HISTORIC AND DESIGN REVIEW COMMISSION

HDRC CASE NO: 2019-357
ADDRESS: 831 LAMAR ST
LEGAL DESCRIPTION: NCB 1368 BLK 5 LOT 21
ZONING: R-6, H
CITY COUNCIL DIST.: 2
DISTRICT: Dignowity Hill Historic District
APPLICANT: Octavio Viramontes/HACAM PROPERTIES LLC
OWNER: Octavio Viramontes/HACAM PROPERTIES LLC
TYPE OF WORK: Construction of a 1-story, single family residential structure
APPLICATION RECEIVED: June 21, 2019
60-DAY REVIEW: August 20, 2019
CASE MANAGER: Edward Hall
REQUEST:

The applicant is requesting a Certificate of Appropriateness for approval to construct one, 1-story single-family residence on the vacant lot at 831 Lamar, located within the Dignowity Hill Historic District.

FLOOR PLAN
SITE PLAN

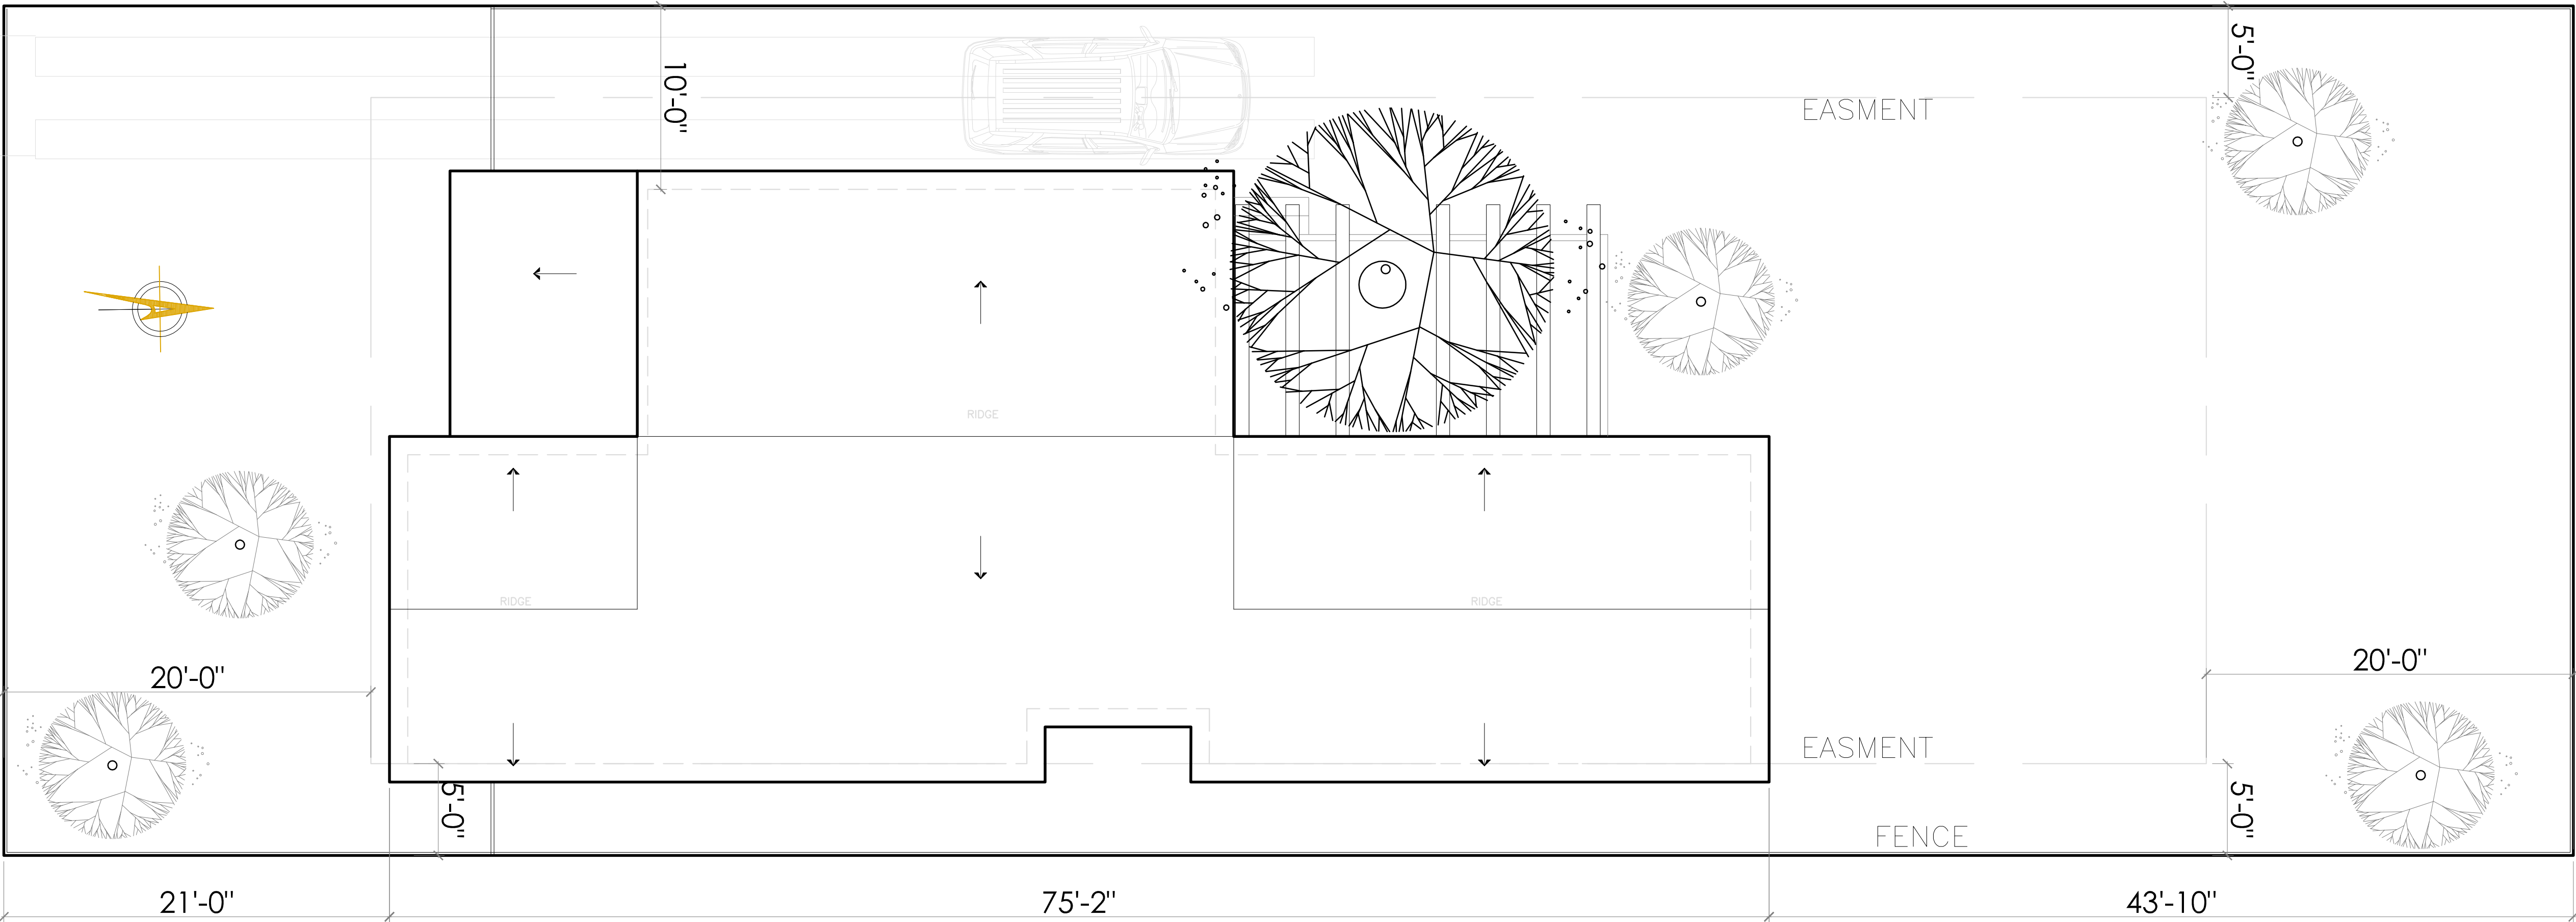
- d. **SETBACKS & ORIENTATION** – According to the Guidelines for New Construction, the front facades of new buildings are to align with front facades of adjacent buildings where a consistent setback has been established along the street frontage. Additionally, the orientation of new construction should be consistent with the historic examples found on the block. The applicant has provided a site plan noting a setback of 20' between the front bay of the house and the front property line. GIS data suggests that this setback is likely not sufficient in order to meet or exceed the setback established by the adjacent historic properties. Staff further finds that the aerial view exhibit provided by the applicant does not appear to be accurate. The applicant is responsible for verifying existing site conditions found on the block face and proposing a setback that conforms with the Historic Design Guidelines.

- g. **FOUNDATION & FLOOR HEIGHTS** – According to the Guidelines for New Construction 2.A.iii., foundation and floor height should be aligned within one (1) foot of neighboring structure's foundation and floor heights. The applicant has noted a foundation height of approximately two (2) feet; however, the applicant should confirm the proposed foundation height.

- m. **DRIVEWAY** – The applicant has proposed a ribbon strip driveway to feature ten (10) feet in width. Staff finds that the proposed driveway is appropriate and consistent with the Guidelines.

- i. That the applicant provide a front setback that is equal to or greater than the setback for the existing historic home located immediately to the west based on finding d. The proposed setbacks should be accurately depicted in the application materials through field verification.

- ii. That the applicant confirm the proposed foundation height is within one (1) foot of those found historically on the block.
- iii. That the applicant increase window heights to be more consistent with those found historically in the district as noted in finding i.
